| Intersection ID: 23225 | Main Street: CARMEL_RD | Cross Street: HILLINGDON_RD | Location:              | W                     |
| ADA ID: 313CB45896EA   | Ramp Type: PerpDiag    | Initial Pass/Fail: Fail     | Overall Compliance: No | Severity Score: 21.25 |

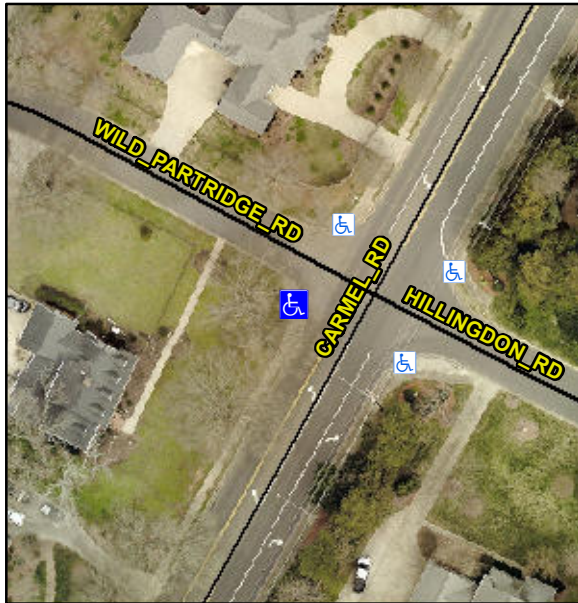
**Not Found, R304.5.1, R304.2.2**

| Compliance | Description           | Data  | Compliance | Description                 | Data  |
|------------|-----------------------|-------|------------|-----------------------------|-------|
| N/A        | Ramp Length (in)      | 77.0  | No         | Ramp Slope (%)              | 10.3  |
| No         | Ramp Width (in)       | 45.0  | Yes        | Ramp XSlope (%)             | 1.7   |

**Remove & Replace Curb Ramp With Two New Directional Ramps or Equivalent.**
